# AIA® Document G709™ – 2018

## Proposal Request

Textron West Campus  
C3 Brite Works

Proposal Request Number: 005

C-201  
WEST CAMPUS - C3

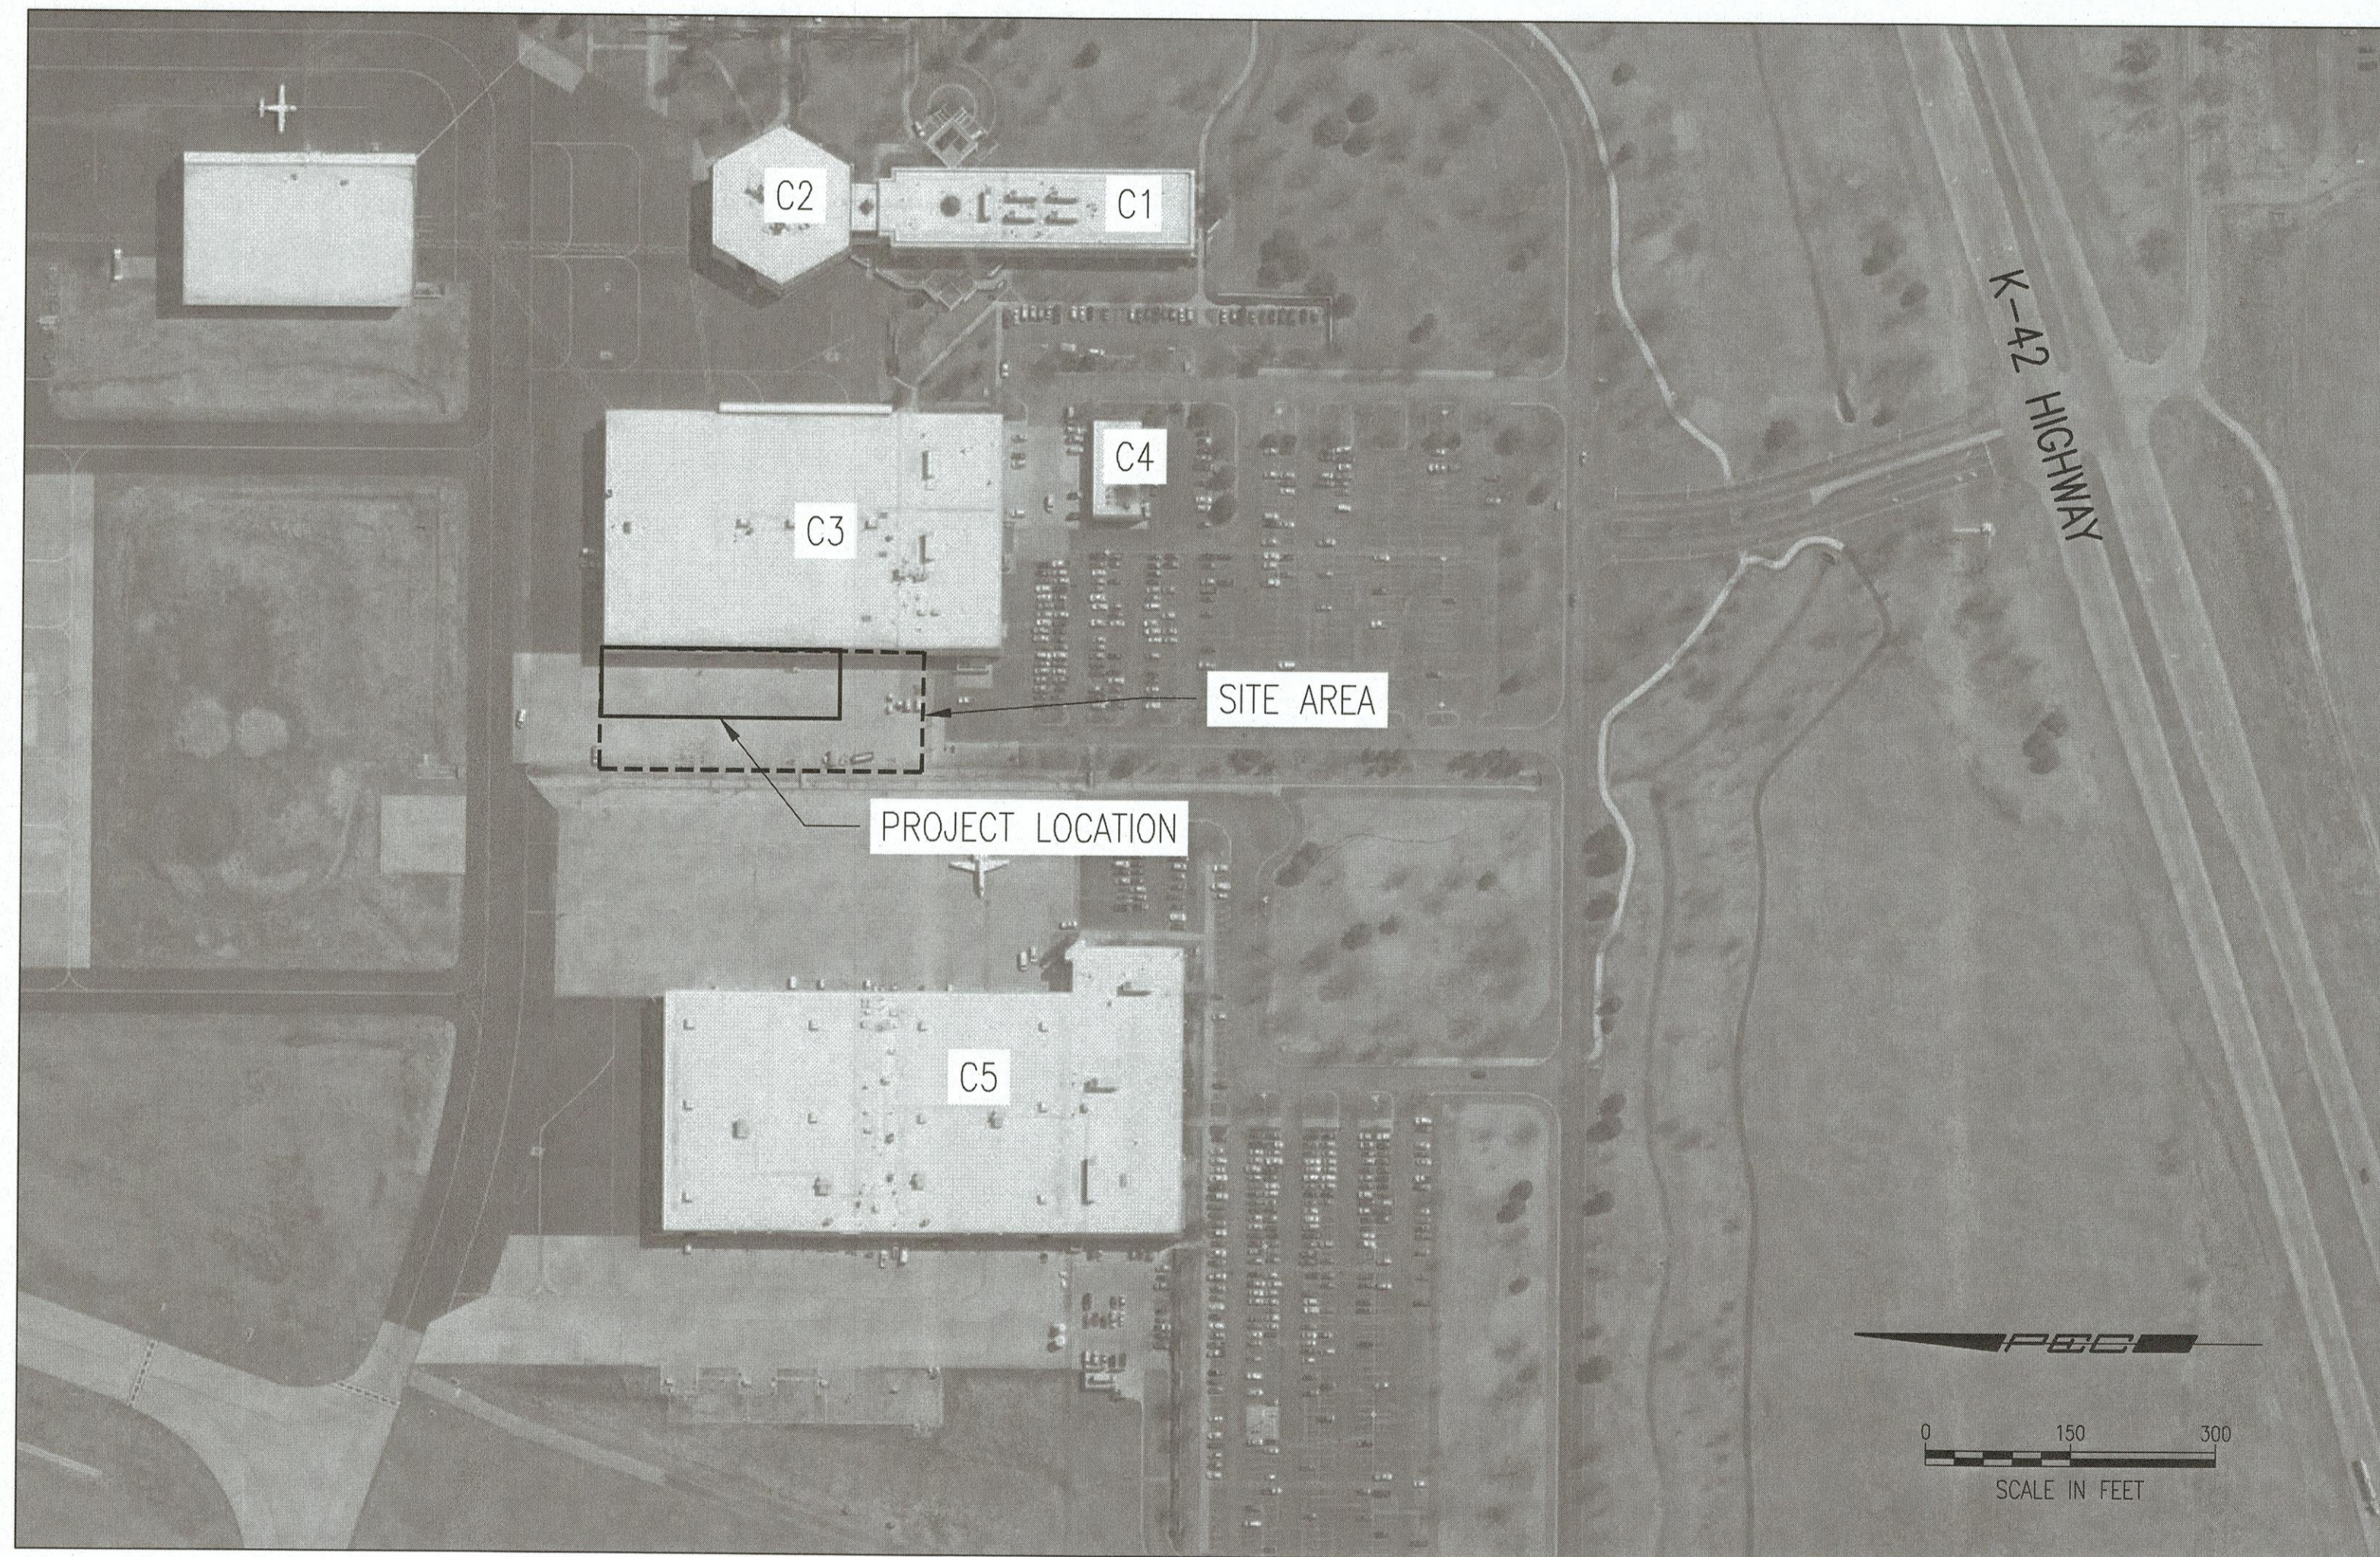
Sheet C-201, C-202, C-203, C-101, C-102, C-103, C-104: Updated for submittal of PPD.

SITE, GRADING AND  
 PAVING PLAN

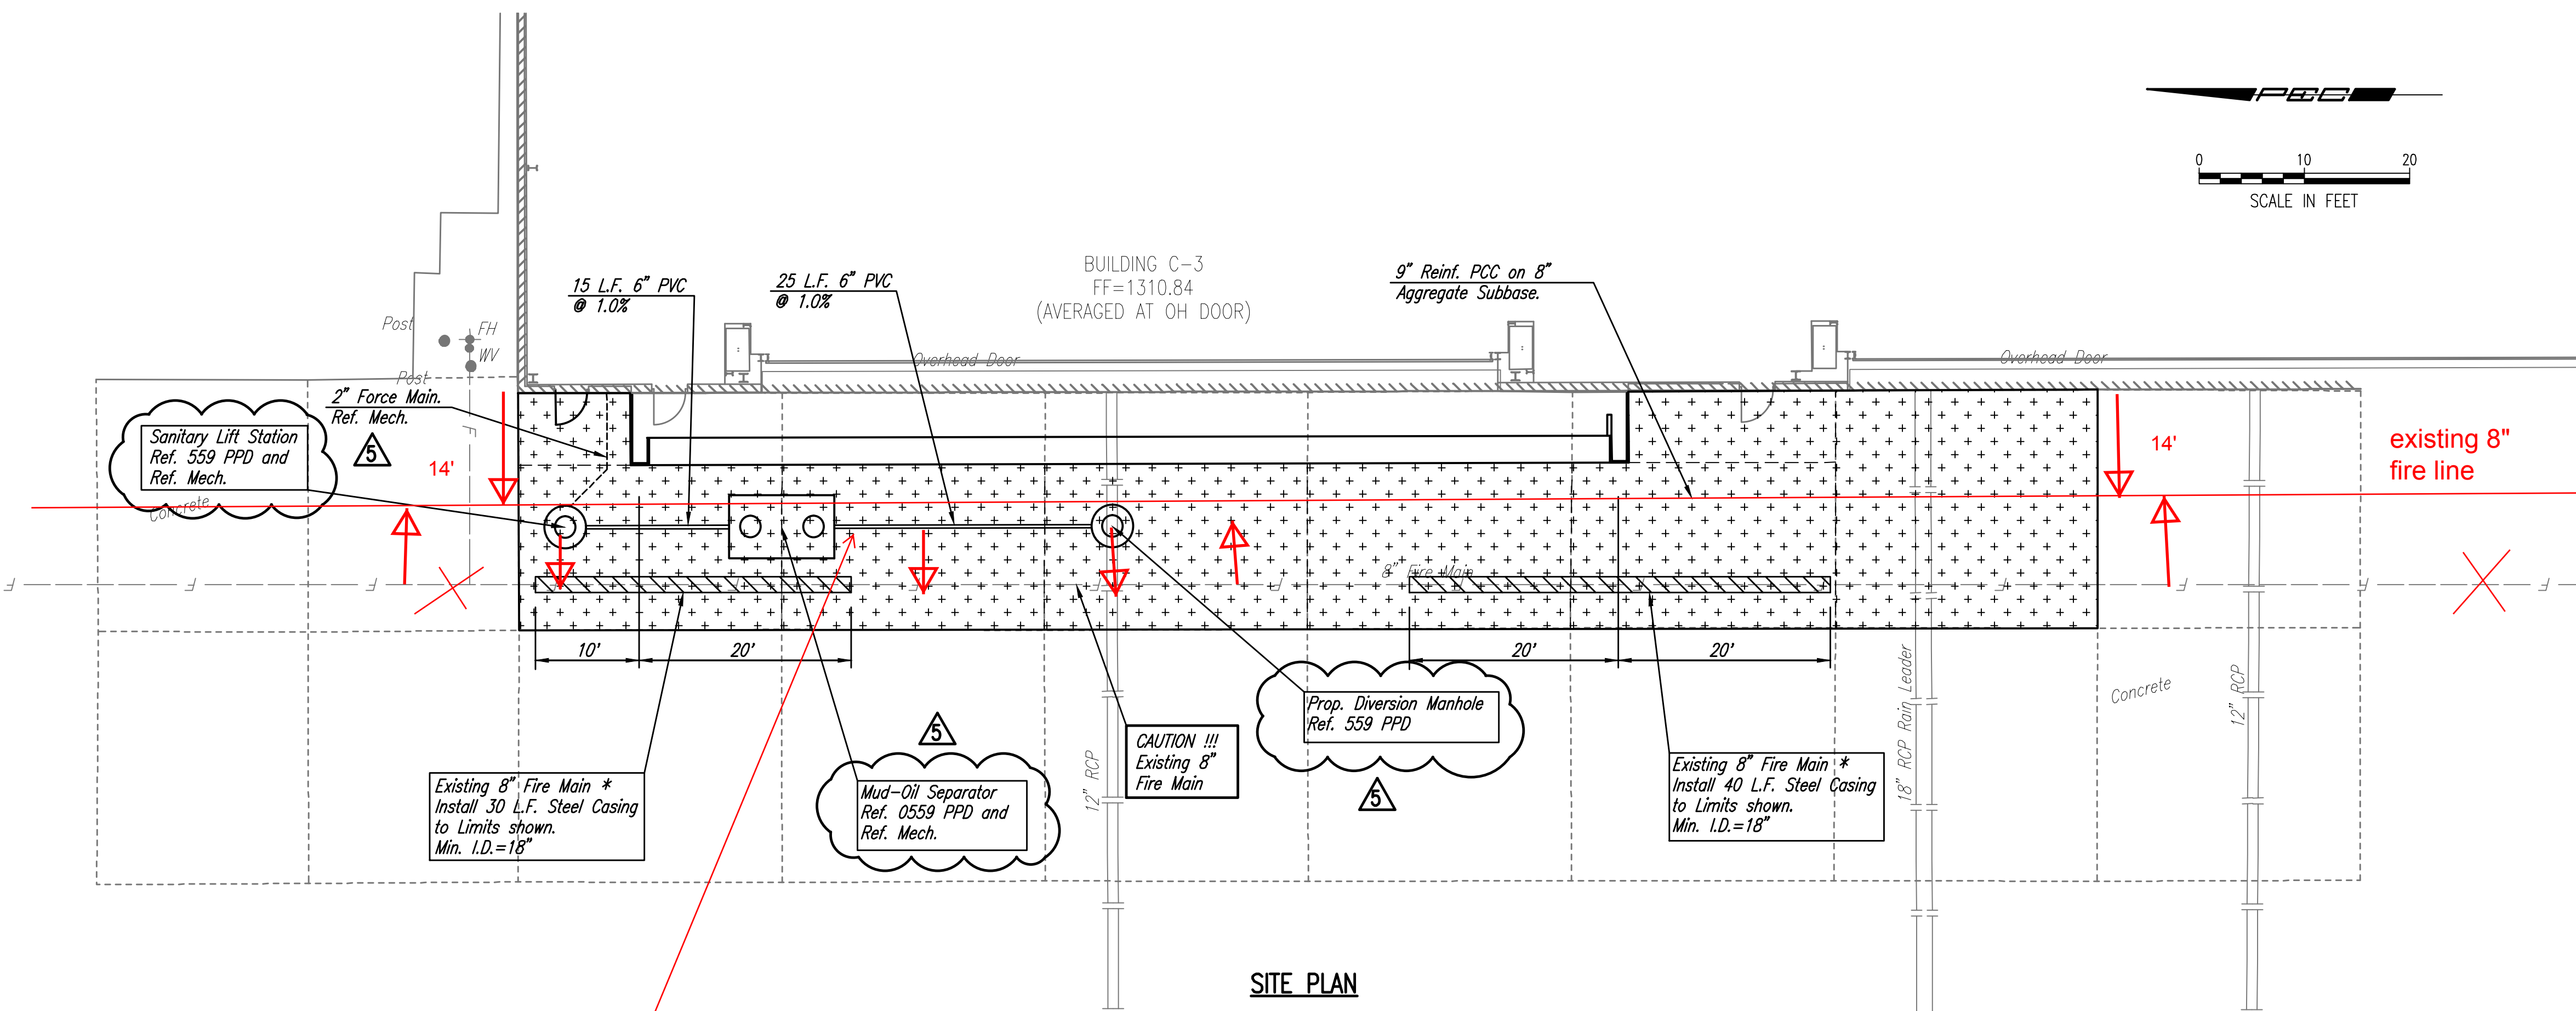
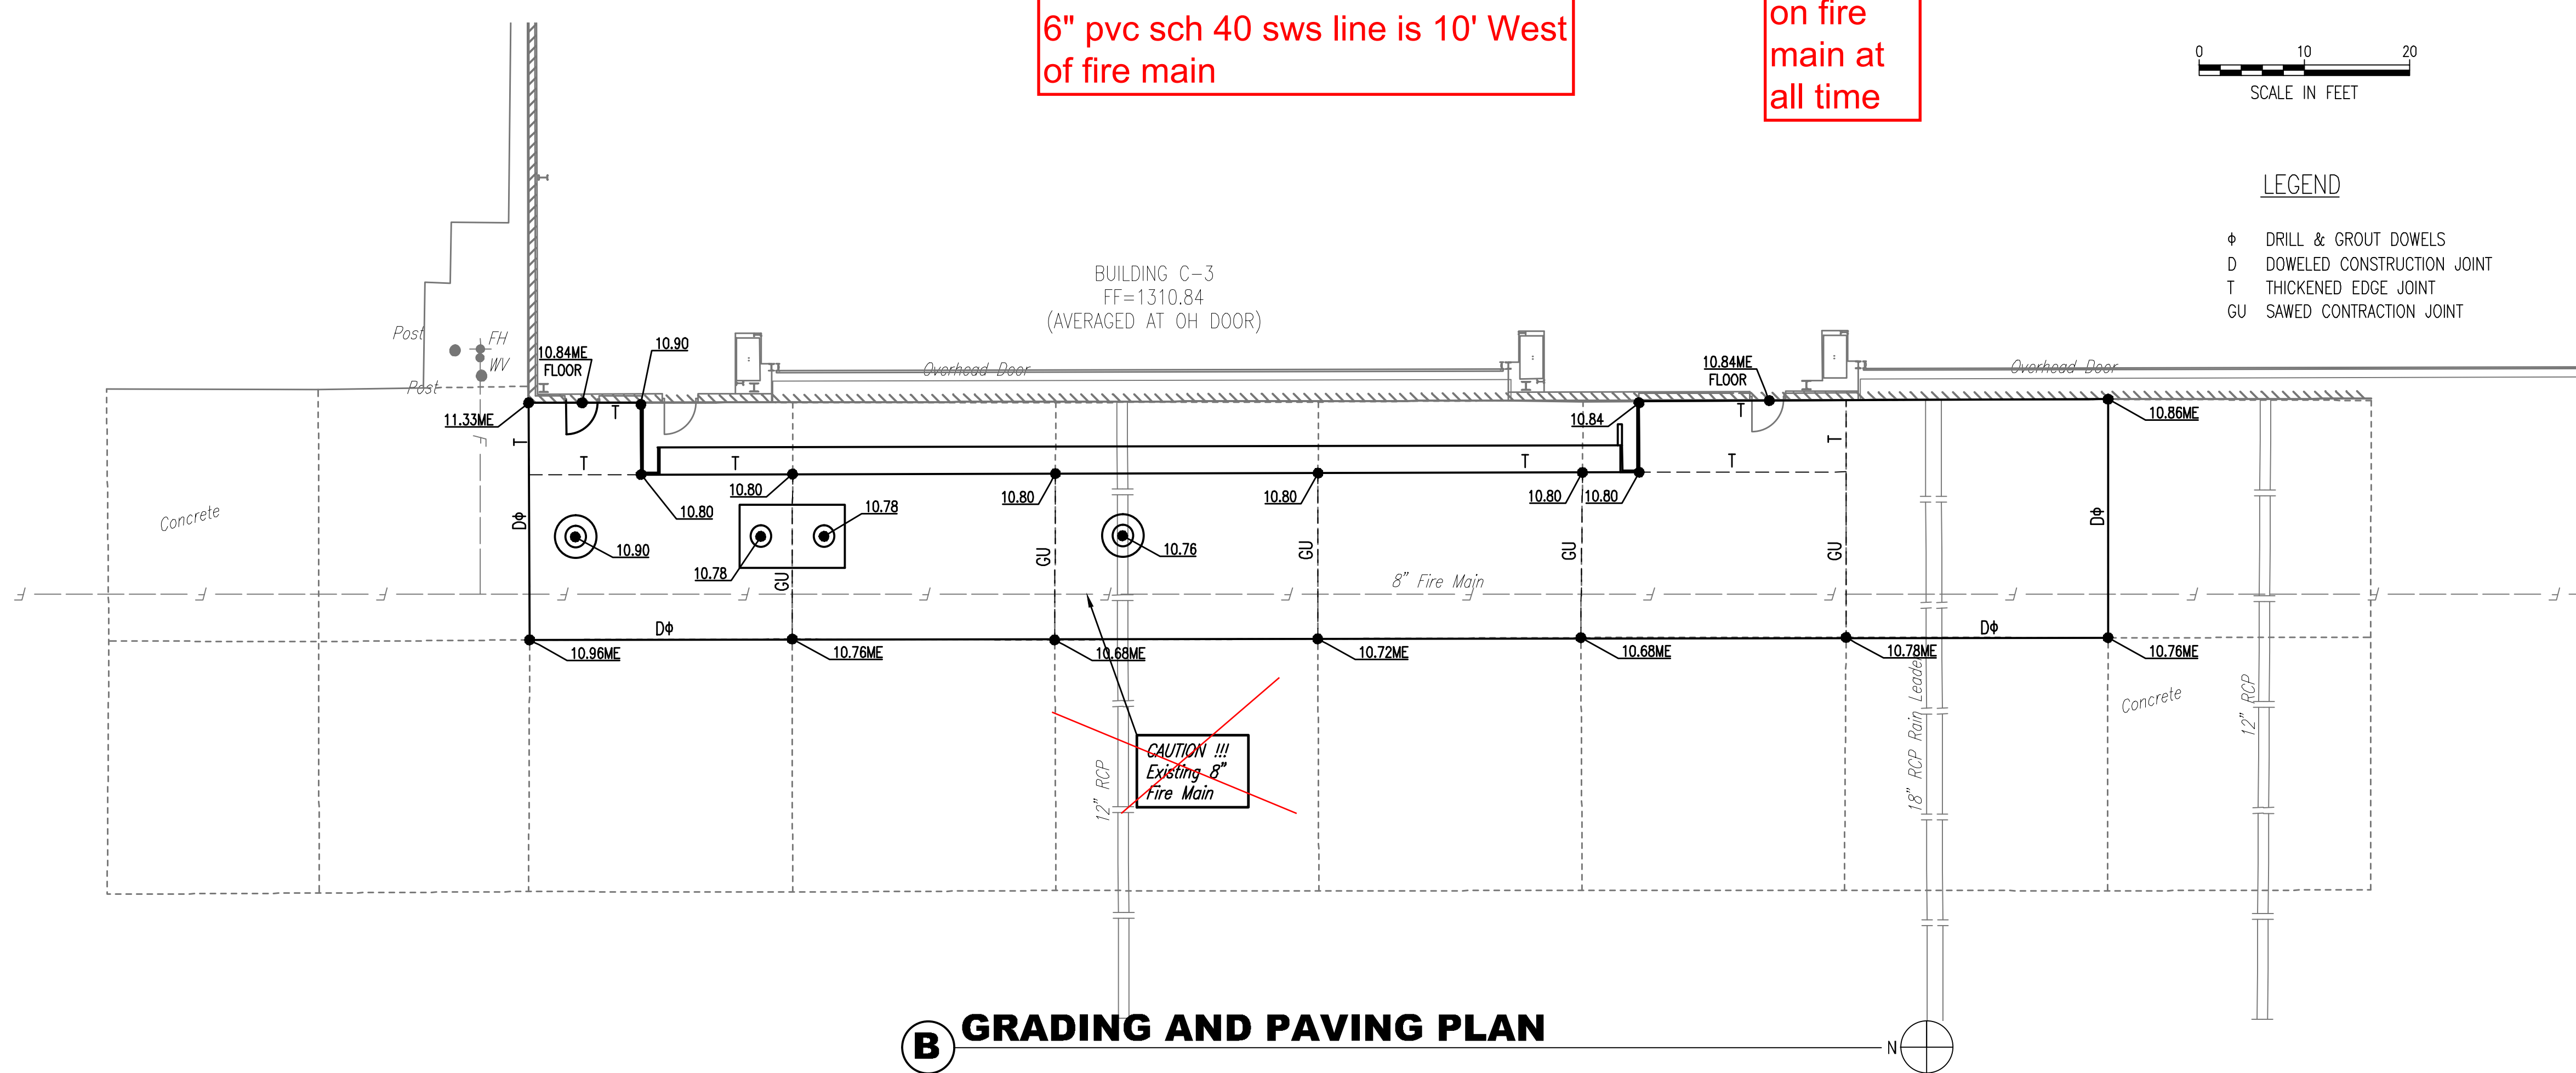
sanitary lift station  
 mud-oil separator  
 diversion manhole  
 and whole line is 10'  
 West of fire line

8" fire main is 14' West of building  
 6" pvc sch 40 sws line is 10' West  
 of fire main

150 psi  
 on fire  
 main at  
 all time
